COMMITTEE OF THE WHOLE JUNE 19, 2006

OFFICIAL PLAN AMENDMENT FILE OP.05.025
ZONING BY-LAW AMENDMENT FILE Z.05.051
SITE DEVELOPMENT FILE DA.05.060
LEOPARD LANE DEVELOPMENT INC. AND SHAREWELL INVESTMENTS INC.
REPORT #P.2006.4

Elevation Plan

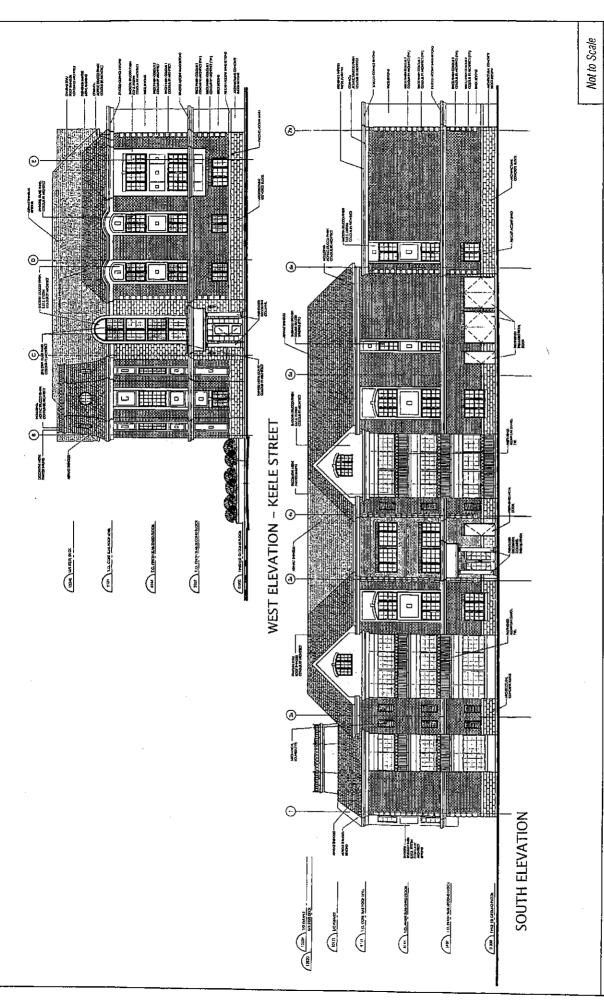
The adjacent neighbour to the rear (east) expressed concerns about noise, screening and their view. The building is setback 4m from the rear lot line, and there will be a landscape strip and new privacy fencing to provide screening. The rear 11.5m of the building incorporates a flat roof to reduce the visual height of the building. The Owner is required to submit a noise report and an external lighting plan to the satisfaction of the Engineering Department.

The proposed building elevations are illustrated on Attachments #4 and #5. The Keele Street (west) elevation is comprised of a variety of materials including brick, architectural block, and stucco articulated in a manner to create visual interest to the building and address the massing of the structure. A stucco accent band above the first storey is carried around the building to further address the massing of the building elevations. The architectural concrete blocks (replica stone) are carried vertically from the building base to the front entrance to create a distinct pedestrian entry feature from Keele Street. A flat roof, accented with a decorative metal railing, septagonal tower is located at the north end of the Keele Street elevation. The elevations include mostly warm red and yellow brick with minor stucco accents framing the windows with architectural concrete block accents at the base of the ground floor level, as shown on Attachments #4 and #5. Prefinished aluminum railings for the proposed balconies on the south, north and east elevations provide visual accents.

Elevation Plan

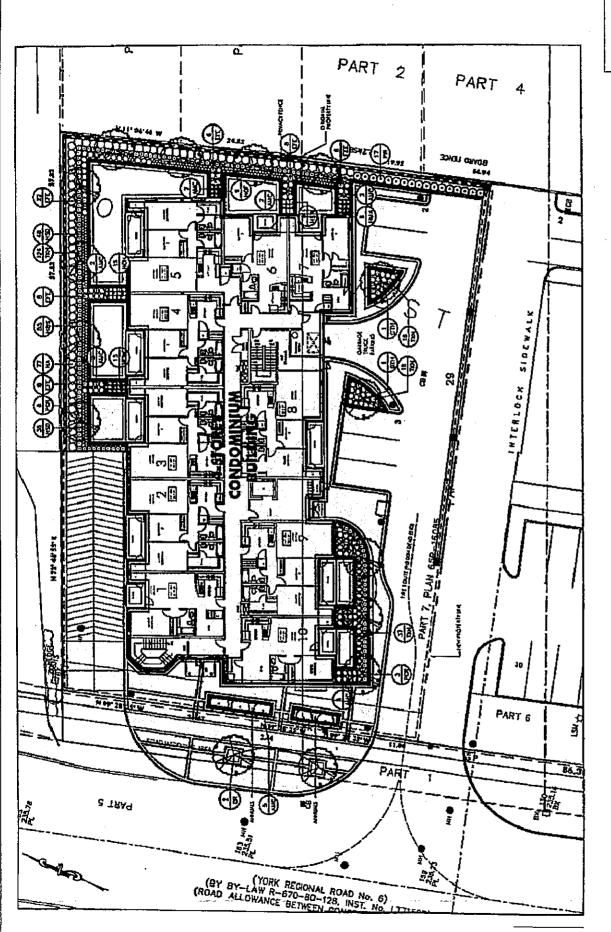
The Owner is proposing fake spandrel glass panels on the front (west) elevation, as shown on Attachment #5. Fake spandrel glass is not acceptable, and the final elevation plans will be required to be revised by the applicant for approval by the Development Planning Department.
